# UNITED STATES PATENT AND TRADEMARK OFFICE

| APPLICATION NO.  | FILING DATE | FIRST NAMED INVENTOR | ATTORNEY DOCKET NO.   | CONFIRMATION NO. |
|--|-------------|----------------------|-----------------------|------------------|
| 10/811,799   | 03/29/2004  | Ace R. Collier       | SESF                  | 2773             |

## DETAILED ACTION

## Automobile Wheel and Track Snare

FIG 10.

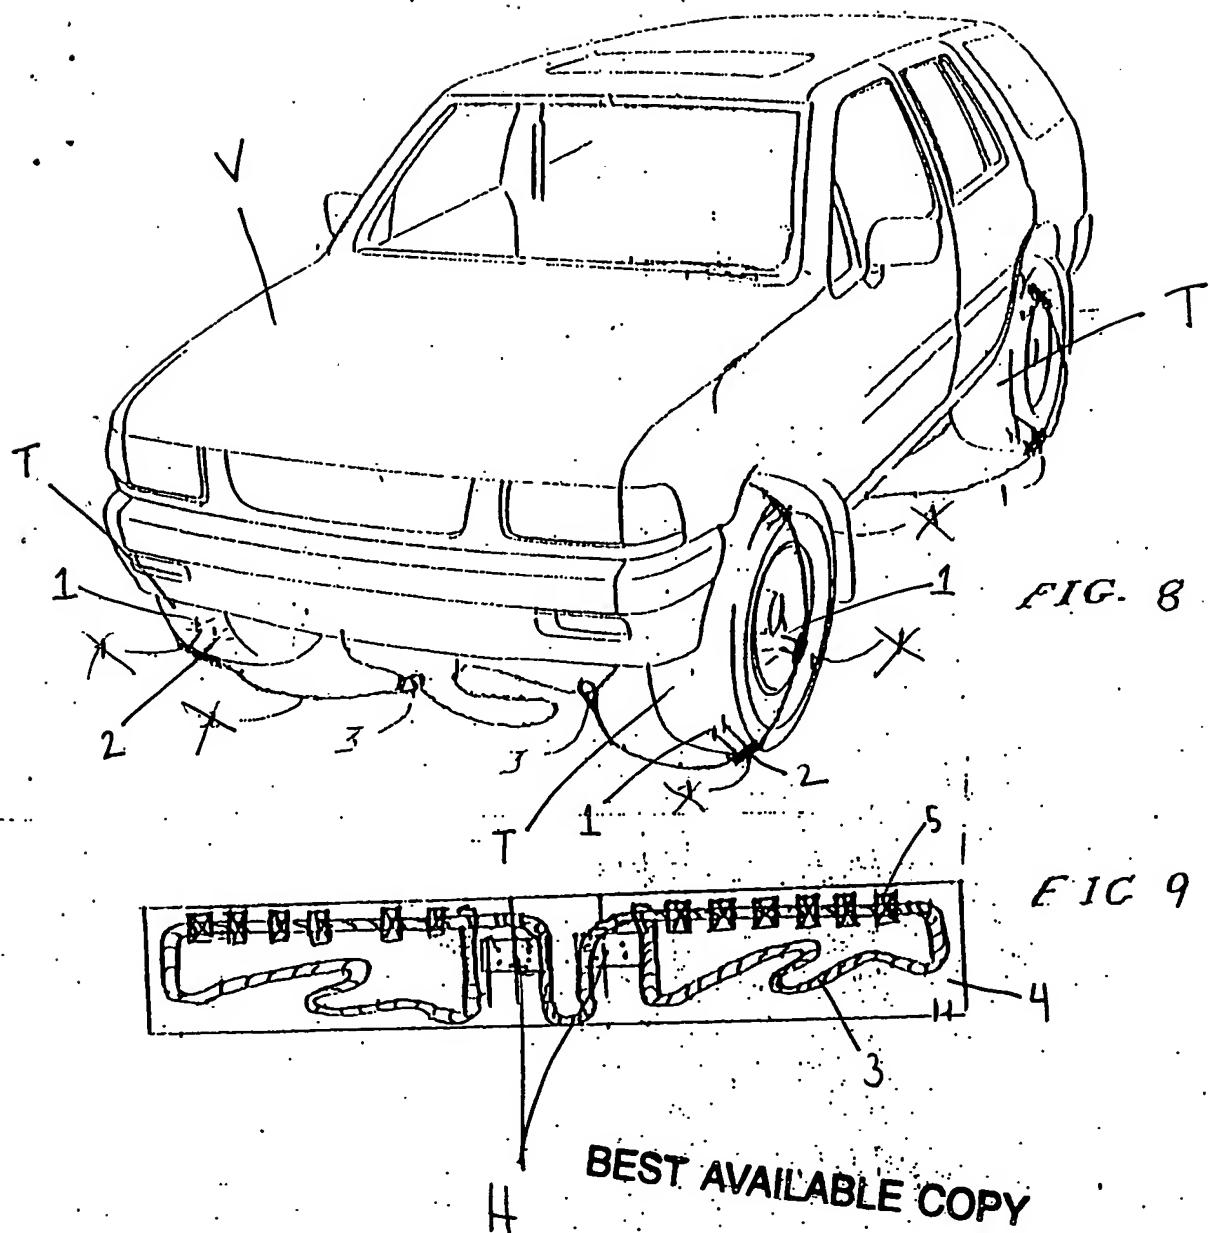
~~CLAIM 13~~

20 MM.

~~2 GUN~~  
~~3"~~

~~60 TON~~  
~~TANK~~

~~BRAKE~~  
~~STOPPED~~  
~~THE~~  
~~COLLIER WHEEL~~  
~~AND TRACER~~  
~~SNARE~~

~~CHAINS~~  
~~STEEL~~  
~~CABLE WITH~~  
~~BASE PLATE~~  
~~AND GRAPPLING~~  
~~HOOKS~~

~~SLEEVE~~  
~~FOR LASSO~~  
~~EFFECT~~

~~ROLLED CABLE~~  
~~WITH GRAPPLING~~  
~~HOOK CAN BE~~  
~~DISPLAYED~~  
~~ON PALLET~~
